Intel[®] Pentium[®] II Xeon[™] Processor Specification Update

Release Date: March 2000

Order Number: 243776-021

The Pentium[®] II Xeon processor may contain design defects or errors known as errata which may cause the product to deviate from published specifications. Current characterized errata are documented in this Specification Update.

D30. Thermal Sensor May Assert SMBALERT# Incorrectly

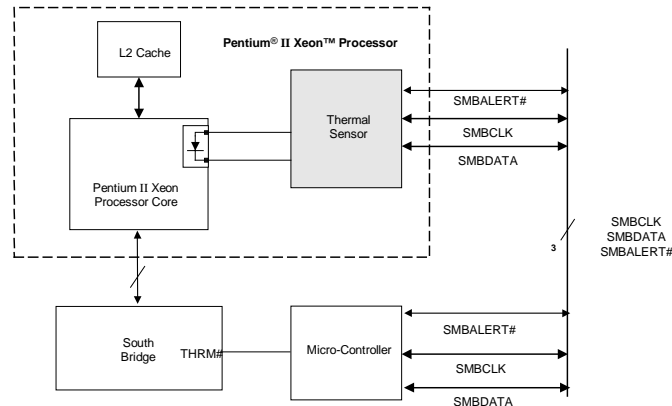
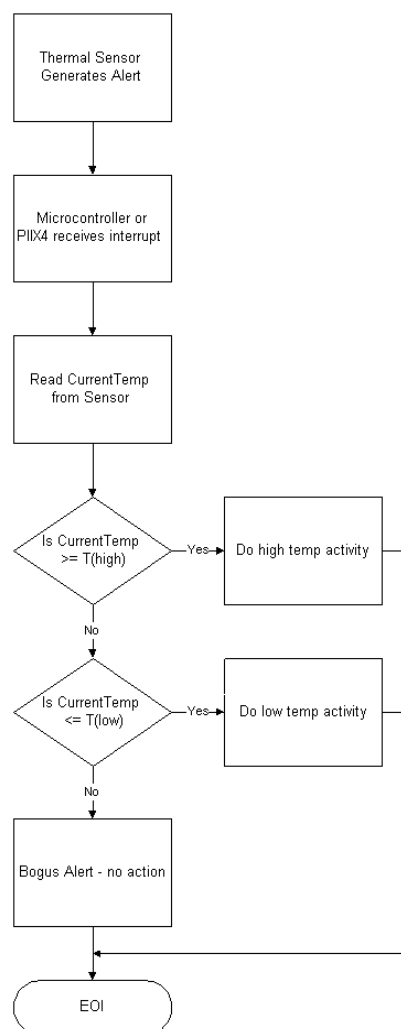
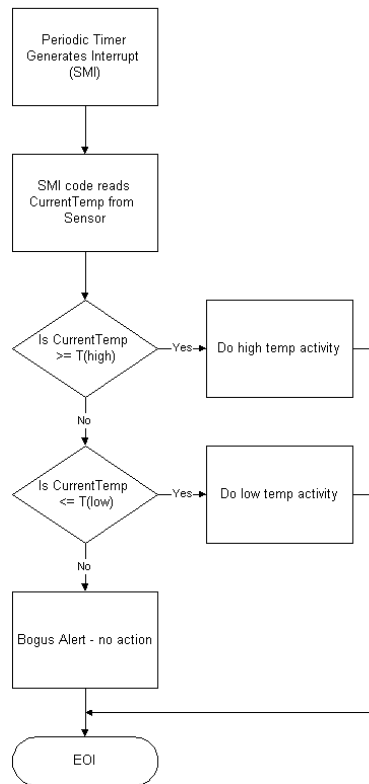
Problem: The Pentium II Xeon processor has a thermal sensor that monitors the processor core's temperature. The thermal sensor asserts SMBALERT# if the processor temperature exceeds the temperature limits set in the Alarm Threshold Registers (T_{HIGH} , T_{LOW}). It also sets the corresponding Status Register bits to identify the cause of the interrupt. Figure 1 gives one example of the how the SMBALERT# signal could be used in a system.

Under the conditions described below, the thermal sensor incorrectly generates the SMBALERT# interrupt. All of the following conditions must be met to trigger a false interrupt:

Workaround: Three different (mutually exclusive) workarounds are possible:

1. Before servicing an interrupt from the thermal sensor, read and compare the processor thermal reading with the threshold limits (T_{HIGH} or T_{LOW}). Figures 2 and 3 provide basic flowcharts for the implementation of this workaround in an interrupt driven system.
2. If the firmware implemented polls the Status Register only, then before taking any action, re-read the temperature register and do a comparison with the alarm threshold limits (T_{HIGH} or T_{LOW}) to determine if the value is actually still within the temperature window.
3. Use a temperature polling scheme to monitor the processor temperature
